SERVICE BULLETIN

FUJI HEAVY INDUSTRIES LTD.

NO : FAS-048

1. SUBJECT : Addition of Sliding Canopy Ceiling Window.
2. AIRCRAFT AFFECTED : All FA-200 Series Aircraft.
3. PRIORITY : Optional.
4. REASON : In order to provide ceiling windows in the sliding canopy for improving upward visibility during acrobatic maneuver.
5. DESCRIPTION : Colored glass windows to be provided in the sliding canopy.
6. ACCOMPLISHMENT : Optional.
7. APPROVAL : JCAB Approval (NO-TOKYO-023) May 19, 1971.
8. PART REQUIRED : The following parts are required to perform the modification:

FIG. 1

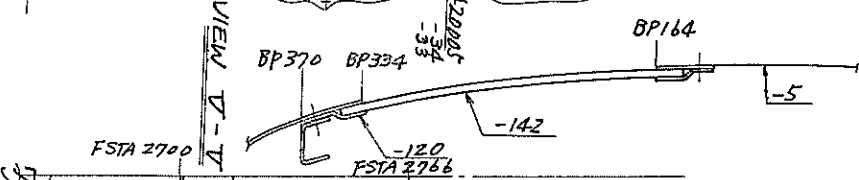
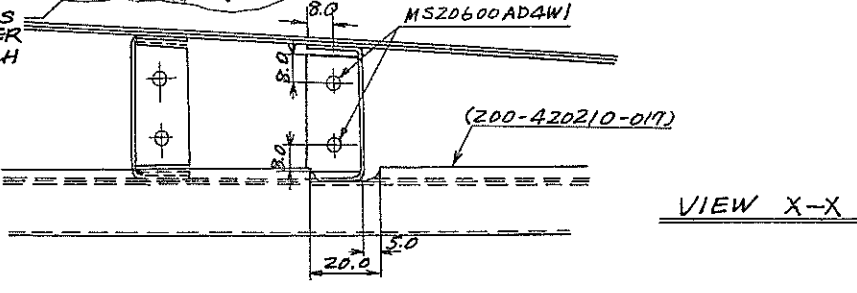
- (1) Remove sliding canopy assy in accordance with Service Manual para.7-4-1.
- (2) Remove screws attaching ceiling covers and remove the covers, 200-534105-3 and -5.
- (3) Remove soundproof blankets, 200-534102-055 and -056 (1 each), and 200-534102-057 (2 each).
- (4) Make two holes in ceiling skin: One in the left and the other in the right. Dimensions for the cutout are shown in the figure 1.
- (5) Remove attaching rivets and cut off the hatched portion of stiffeners, 200-420005-33 and -34, as illustrated in figure 1 and in view X-X.
- (6) Cut off stiffener, 200-420210-017, to dimensions as shown in view X-X.

- (7) Position stiffeners, 200-420005-33 and -34, at F. STA 2776 against skin with stiffener flange forward.
- (8) Remove * marked rivets attaching bracket, 200-534321-001, and rivets securing stiffener at BP370, between F. STA 2400 and F. STA 2776, as illustrated in figure 1.

- (9) Position glass supports, 200-420005-119 and -120, as shown in figure 1. Using existing holes in the skin as a guide, and also referring to hole locations shown in figure 1, drill rivet holes through skin, glass supports, and stiffeners.

- (11) Install rivets to secure stiffer to skin as illustrated in figure 1 and in view X-X.
- (12) Plug remaining rivet holes with rivets, MS20470AD4.
- (13) Cut out ceiling covers, 200-534105-3 and -5, and install seal, F-0416-1200, with cemedine #540 as illustrated in figure 2.

DO NOT REMOVE THIS PORTION OF STIFFENER -33-34. REMOVE HATCH AREA ONLY

FIG. 2

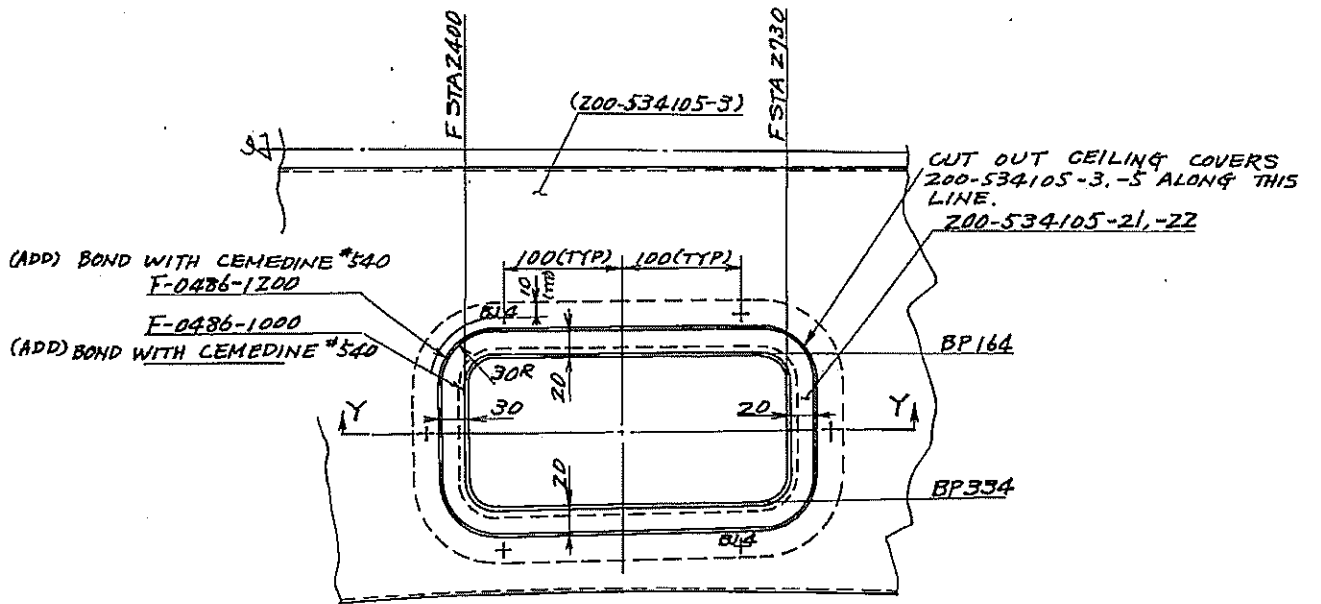
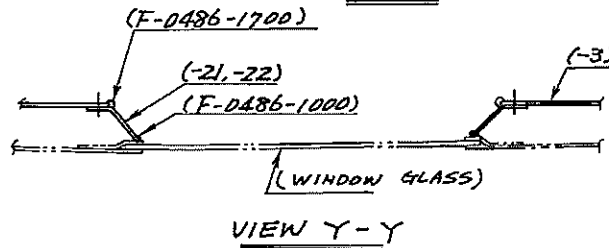
- (14) Install covers, 200-534105-21 and -22, in place with rivets, and bond seal, F-0486-1000, as illustrated in figure 2.
- (15) Cut out ceiling soundproof blankets, 200-534102-055, -056, and -057 as illustrated in figure 3.
